GALLERIA LANDINGS

DEPARTMENT OF SUSTAINABLE DEVELOPMENT - URBAN DESIGN AND PLANNING
DEVELOPMENT REVIEW COMMITTEE SITE PLAN

1180 N. FEDERAL HIGHWAY
FORT LAUDERDALE, FLORIDA

FLOOR PLAN LEVEL 03

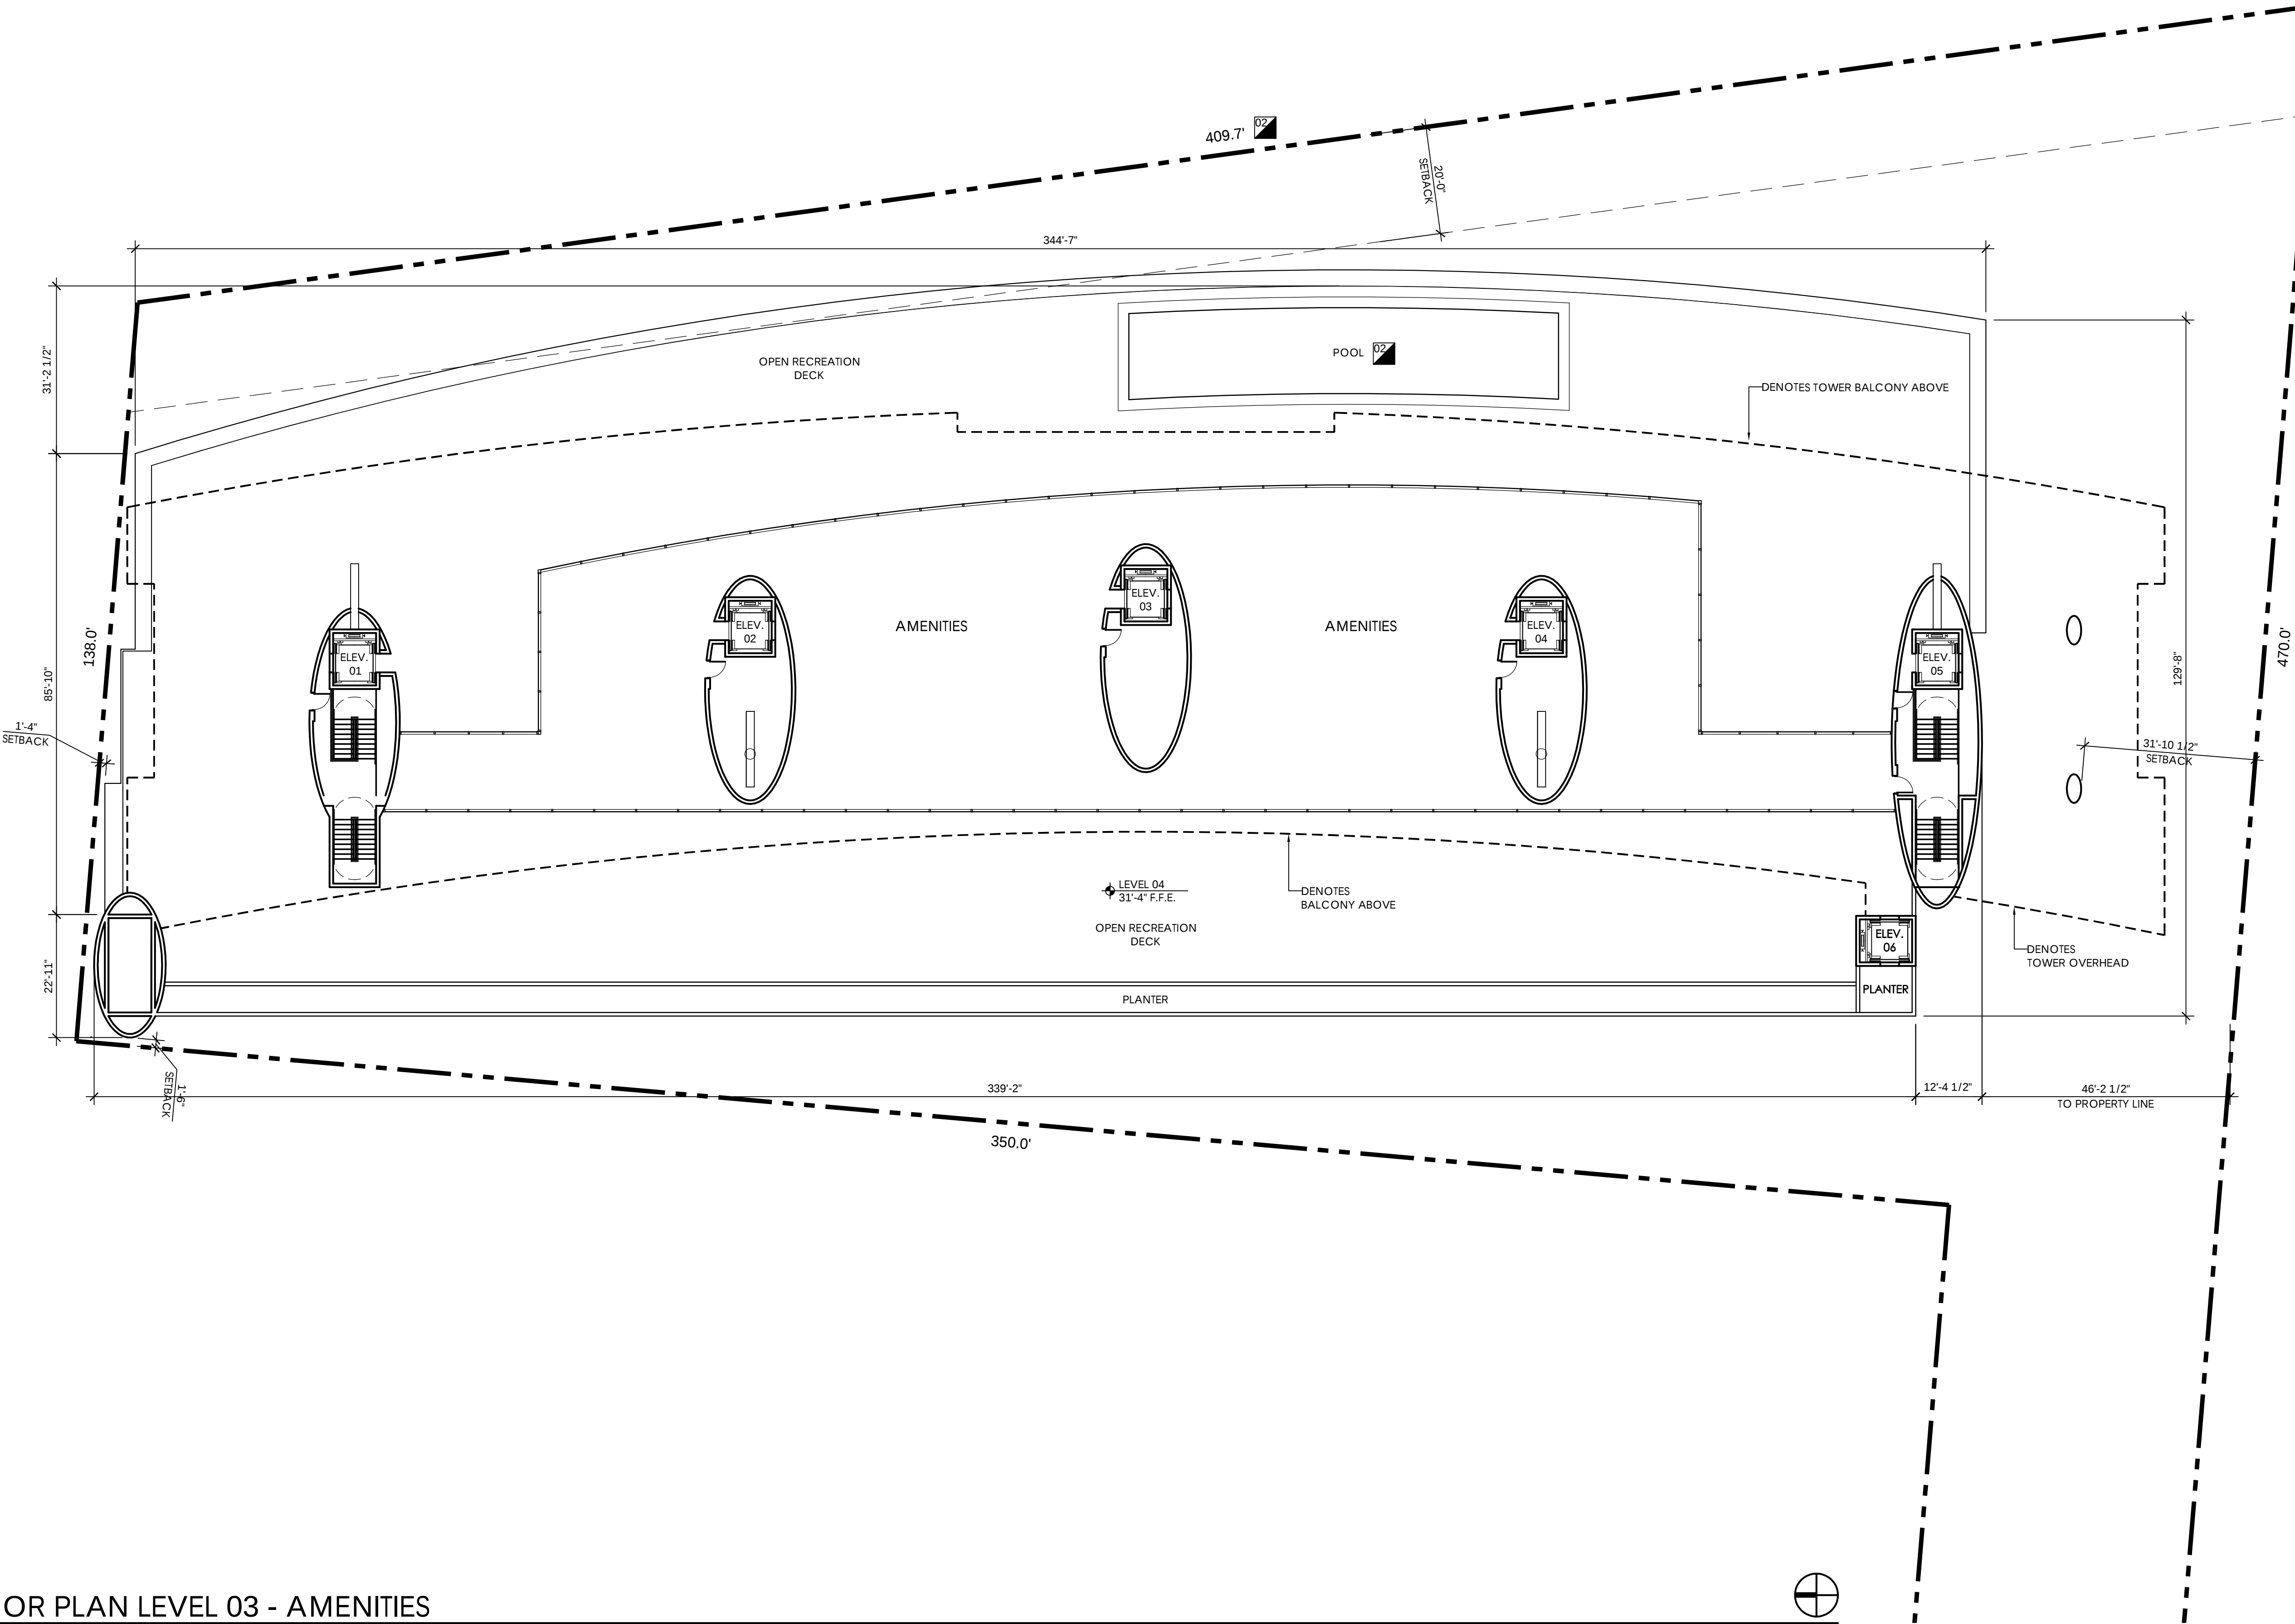
01 DRC COMMENTS
RELOCATION OF GROUND LEVEL
POOL TO AMENITIES LEVEL TO
ACCOMMODATE PUBLIC PLAZA
02 POOL ENLARGED AND RELOCATED
DIMENSION CORRECTED

EXTERIOR ELEVATIONS / DETAILS

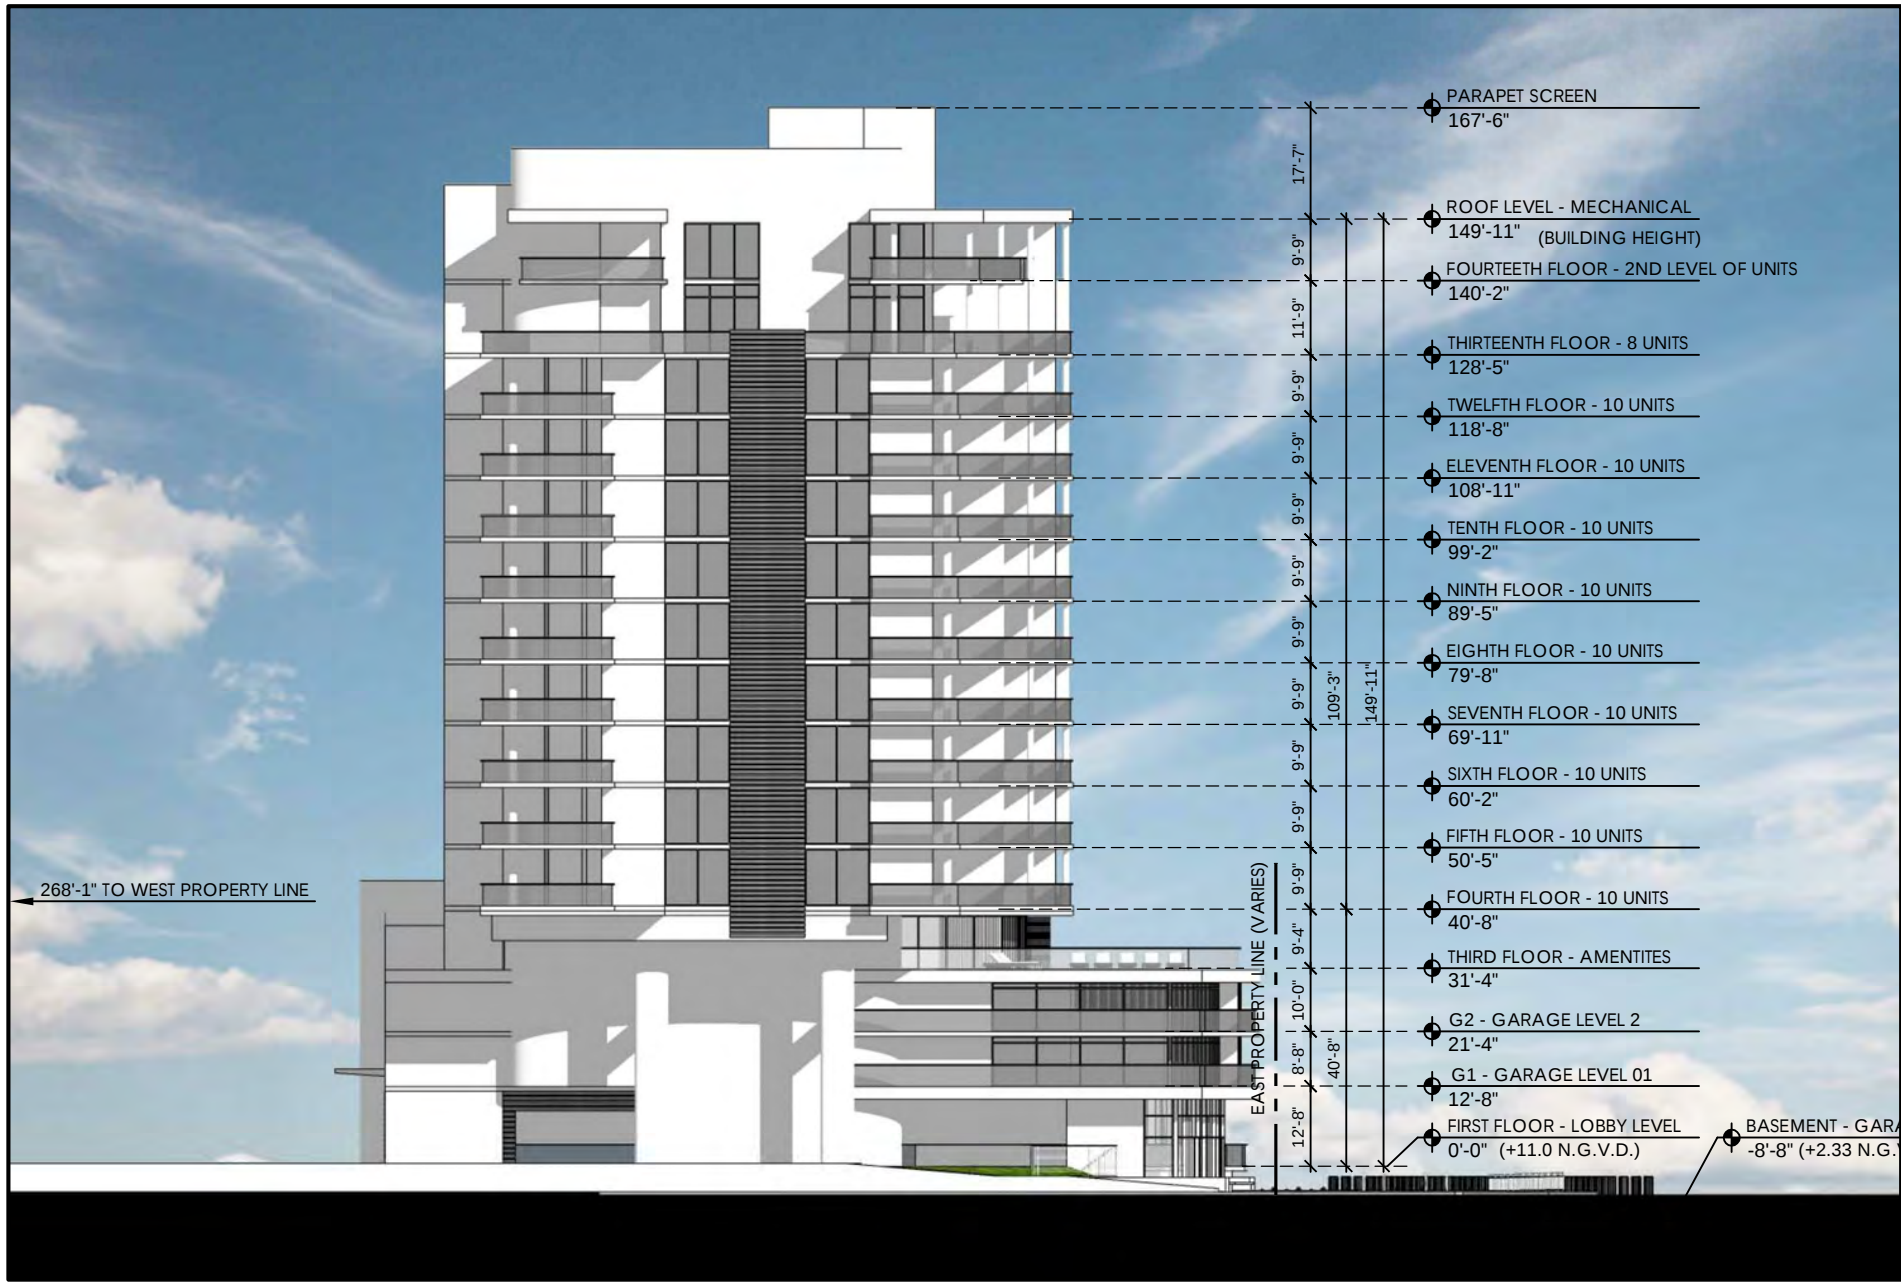
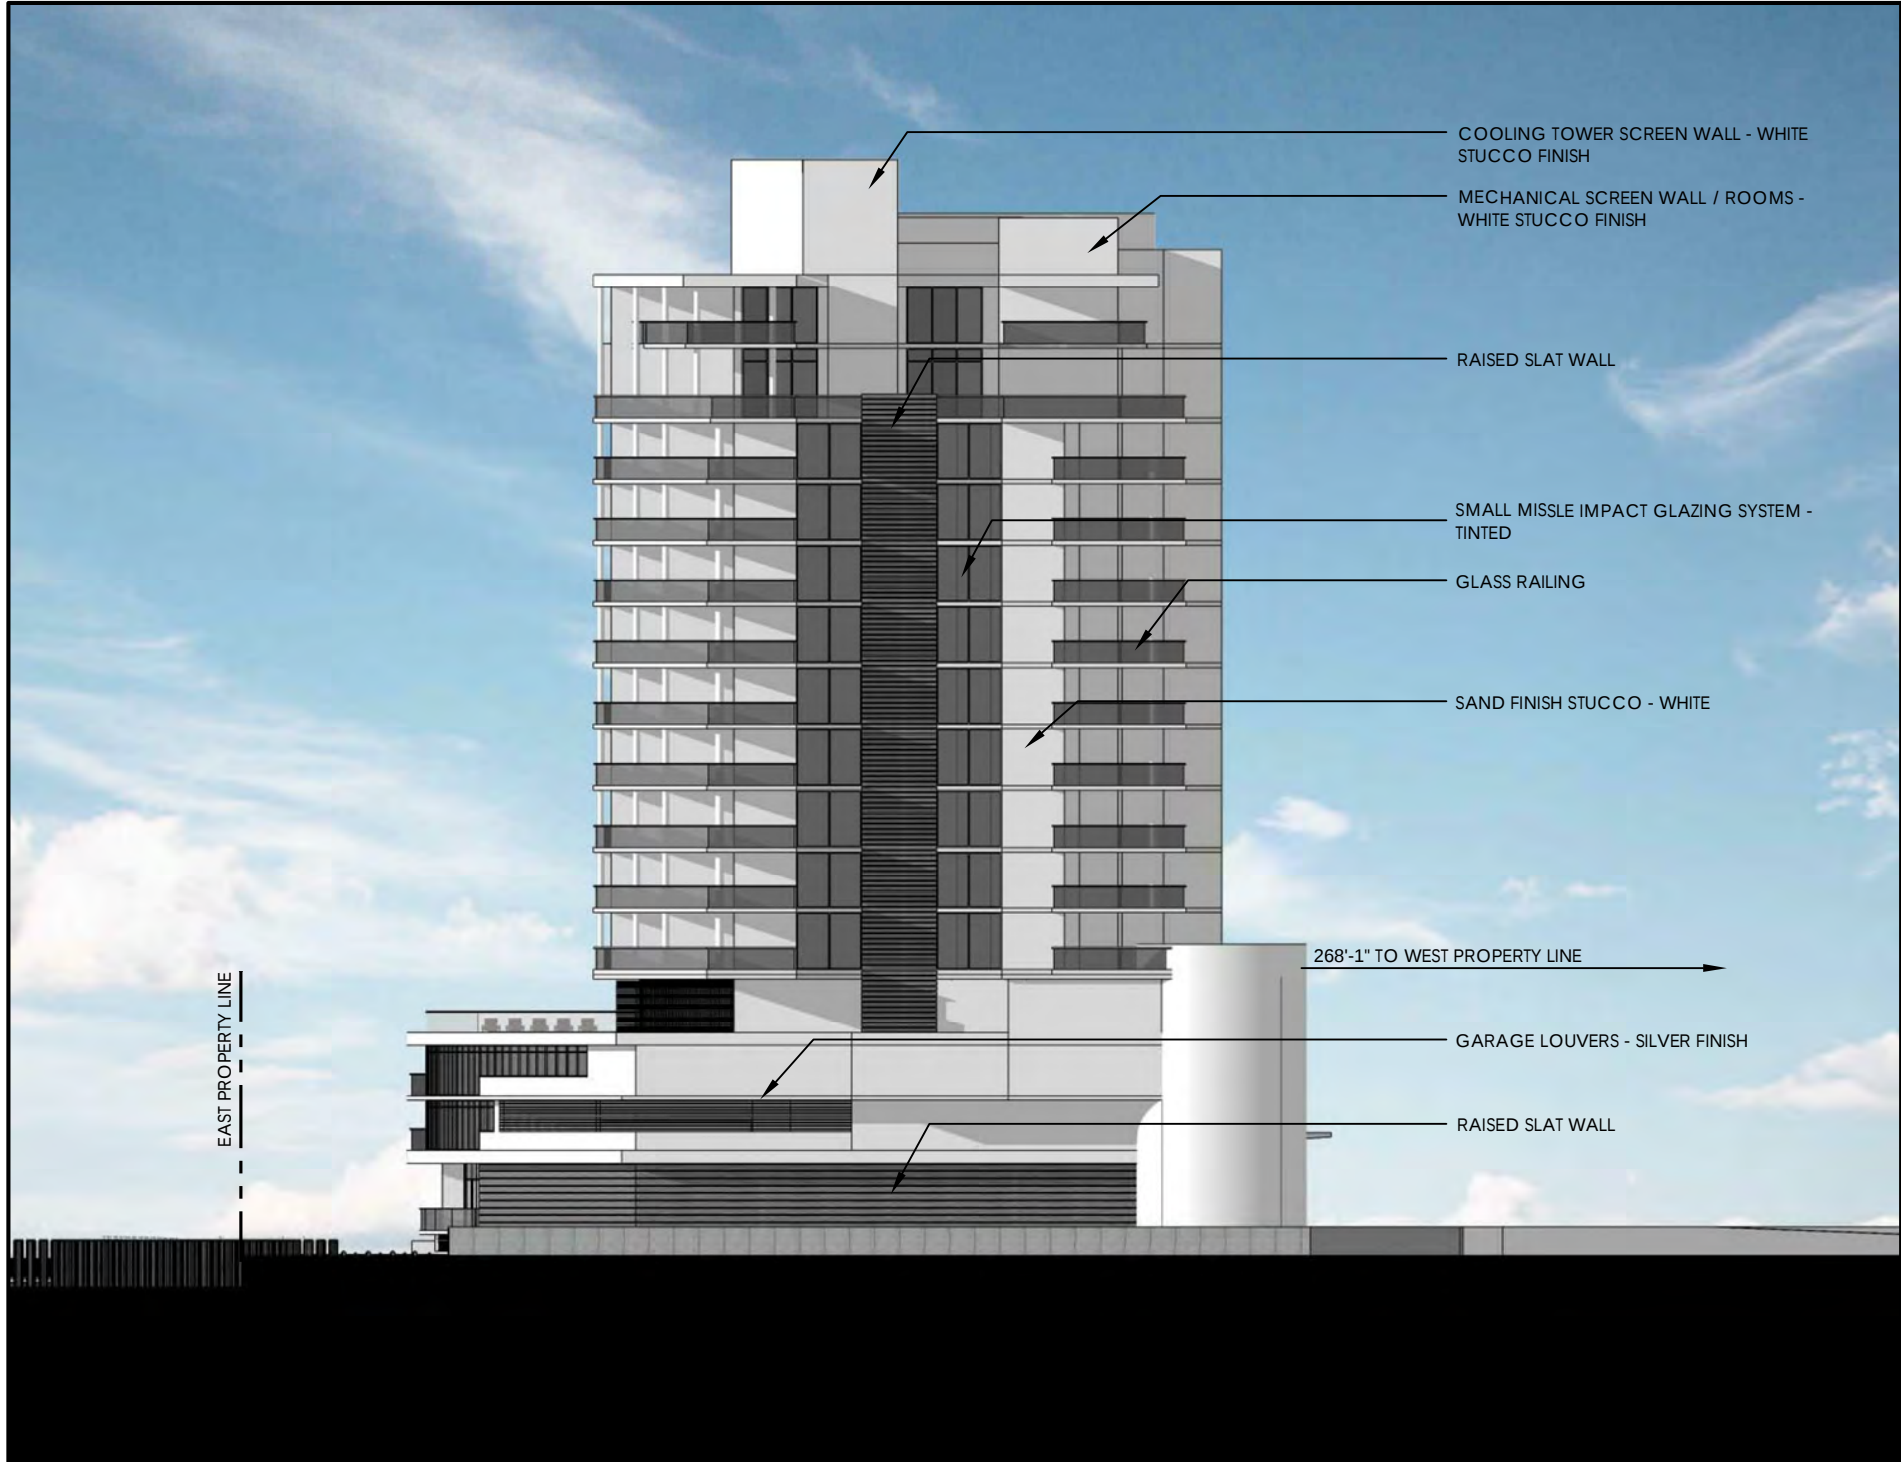
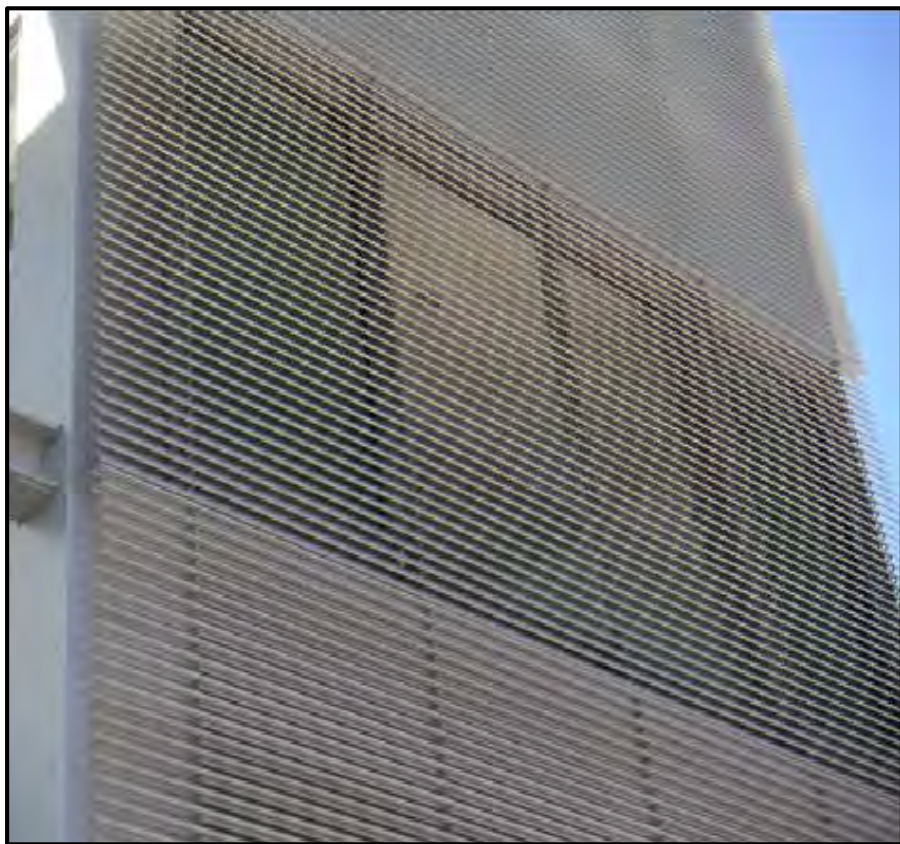
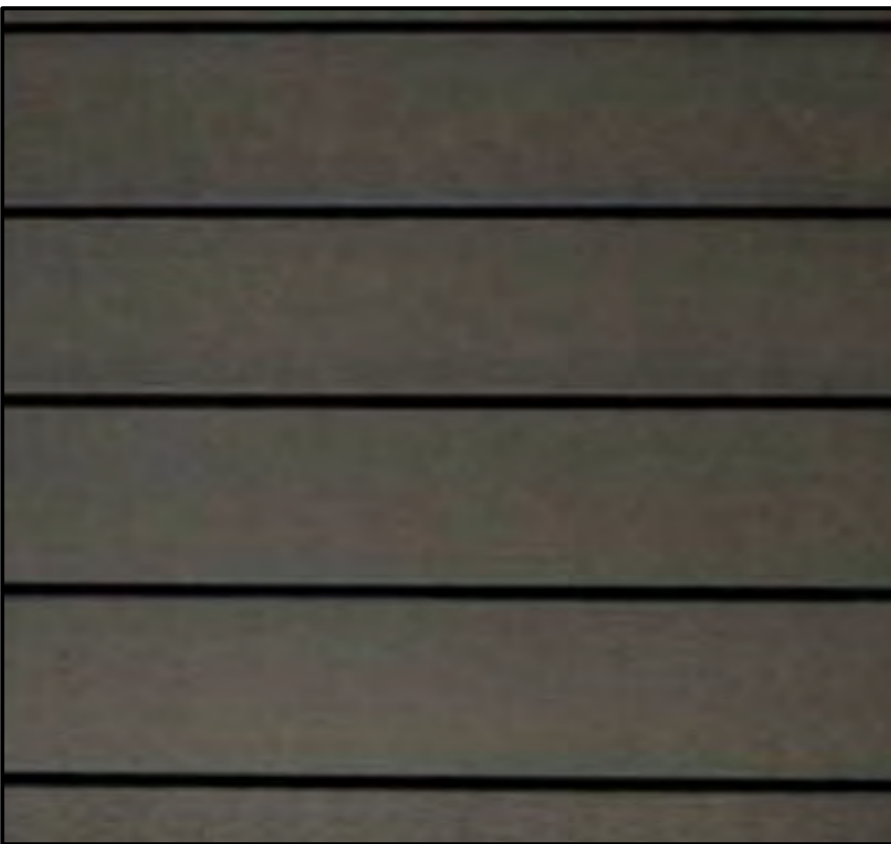
REVISIONS
DRC COMMENTS
VERTICAL COLUMNS ADDED,
MECHANICAL ROOF PARAPET SPLIT AND
LOWERED, GLASS RAILING CHANGE.
